DECISION OF THE PLANNING ADMINISTRATOR

REPLAT TENTATIVE PLAN / CLASS 2 ADJUSTMENT CASE NO.: REP-ADJ25-02

NOTICE OF DECISION DATE: March 5, 2025

Summary: A replat to consolidate six lots into two parcels with two adjustments to lot area and depth.

PROPOSED RE-PLAT

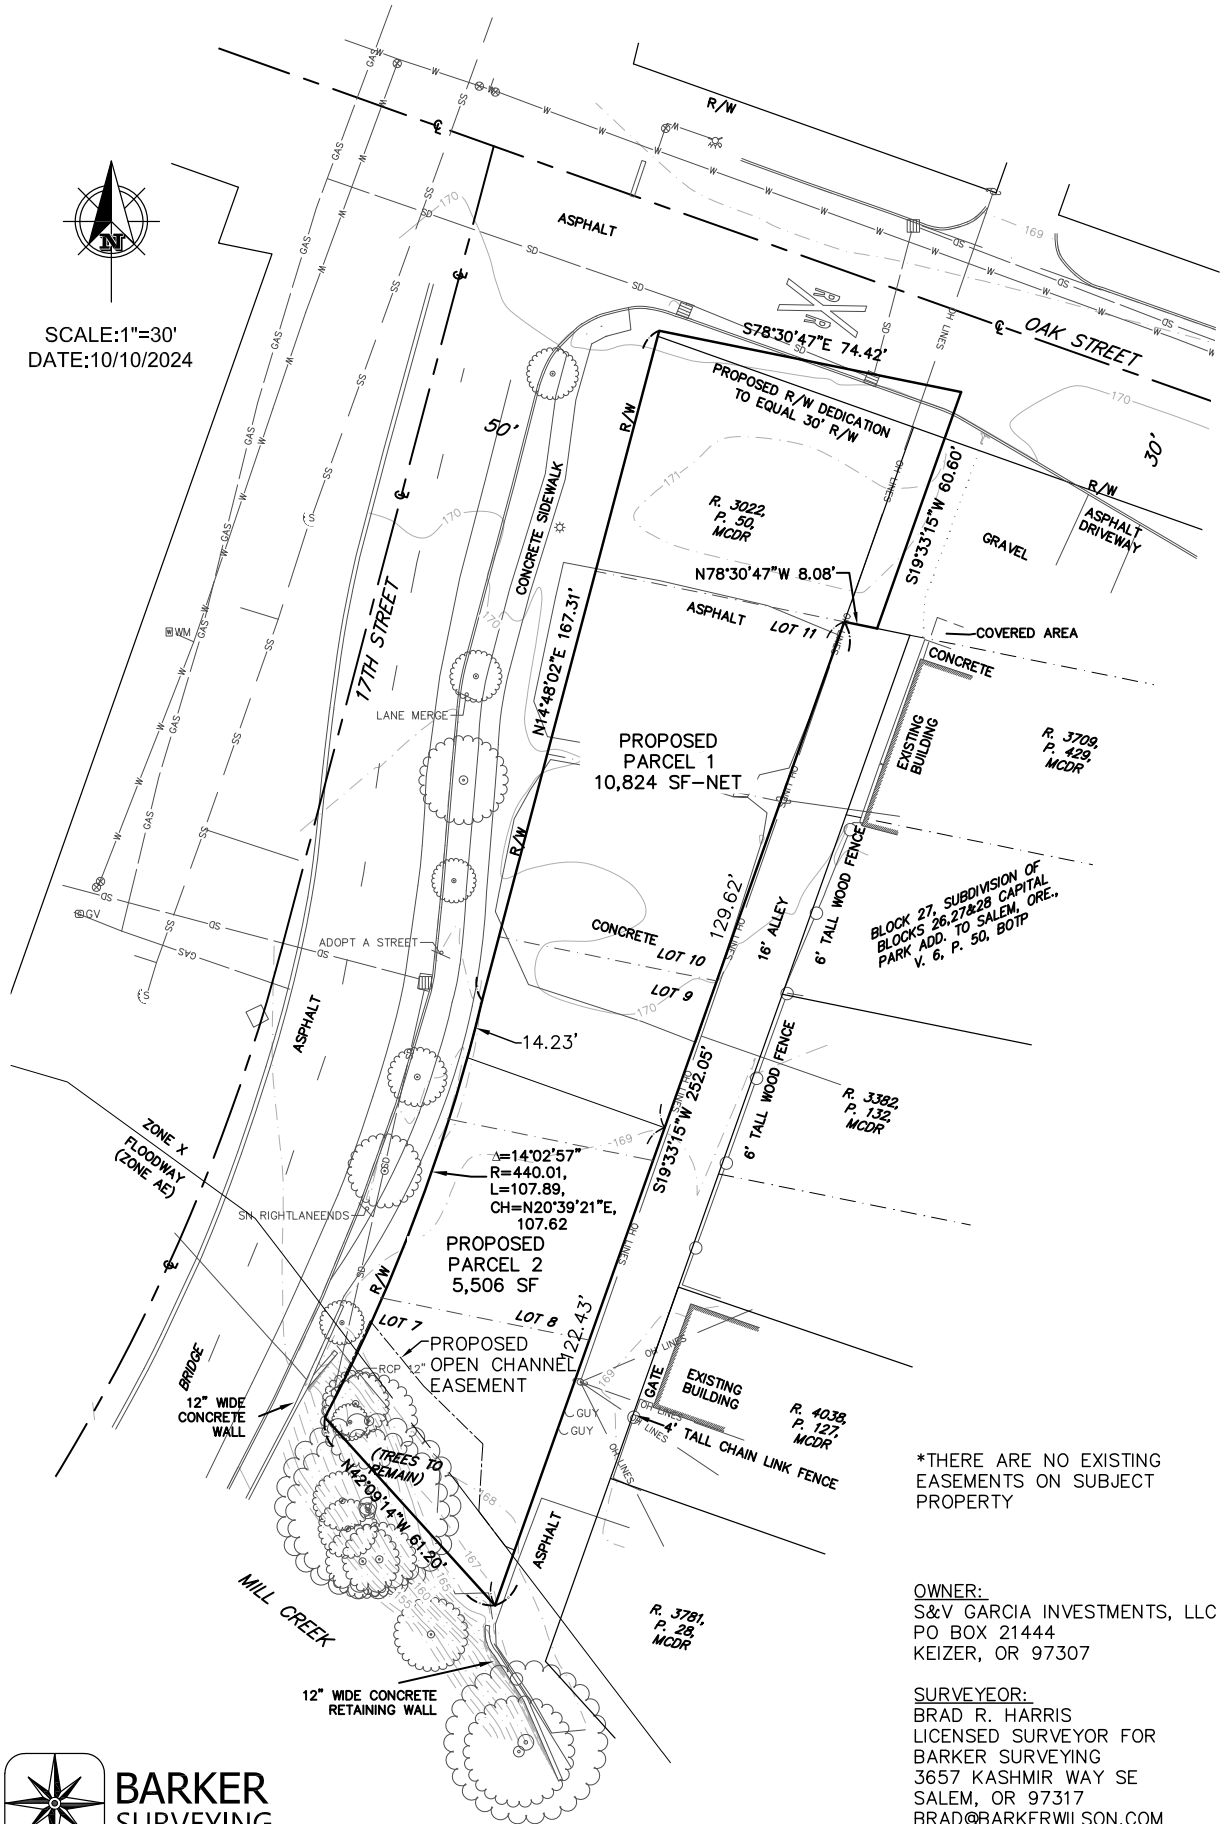
As shown on the replat tentative plan (**Attachment B**), after required right-of-way dedication, proposed Parcel 1 will be approximately 10,824 square feet in size, with 180 feet of street frontage along 17th Street SE, 73 feet of street frontage along Oak Street SE, and will have 58 feet in width and 180 feet in depth, meeting the lot standards of the RM-II zone. Proposed Parcel 2 will be 5,506 square feet, less than the minimum 6,000 square feet, for which the applicant has requested a Class 2 Adjustment. Proposed Parcel 2 will have 93 feet of street frontage along 17th Street SE and will have 107 feet in lot width and 51 feet in lot depth, less than the minimum 80 feet required, for which the applicant has requested a Class 2 Adjustment. The Class 2 Adjustments are addressed in Section 7 of this decision.

As shown on the applicant’s utility plans, there are utilities crossing property lines. A private utility easement is required for the water line crossing proposed Parcel 1 to serve proposed Parcel 2. A private stormwater easement is required crossing proposed Parcel 2 for the private stormwater facility on Parcel 1.

The subject property abuts 17th Street SE to the west and Oak Street SE to the north. Direct access for the subject property will not be permitted onto 17th Street SE, the approved site plan (SPR-ADJ-DAP24-27) indicates that vehicle access for the complex will be provided via Oak Street SE and the abutting public alley to the Driveway access to Oak Street is located on proposed Parcel 1, an access easement shall be provided for the benefit of proposed Parcel 2. All necessary access and private utility easements shall be shown on the final plat.

Reduce the minimum lot size of proposed Parcel 2 from 6,000 square feet to 5,506 square feet, per SRC 514.010(b), Table 514-2.

Reduce the minimum lot depth of proposed Parcel 2 from 80 feet to 51 feet, per SRC 514.010(b), Table 514-2.

As described above, due to the narrow north-south orientation of the development site because of past street widening of 17th Street, the applicant has requested a Class 2 Adjustment to reduce the minimum lot depth of proposed Parcel 2. Due to the narrow site constraints of the property and other development standards of the RM-II zone and the multi-family design review standards, allowing a narrower lot depth is necessary to accommodate future development. Because of the street widening, the lot depth could not be met for this

Condition 1: Prior to issuance of a building permit for development on each parcel, the applicant shall submit a revised utility plan demonstrating how each proposed parcel is independently served by sanitary sewer service, water service lines, and water meters as required by SRC 72.091 (Water Service Connections) and SRC 73.065 (Sanitary Service Connections).

Condition 3: Prior to final plat, all necessary (existing and proposed) access and utility easements must be shown and recorded on the final plat.
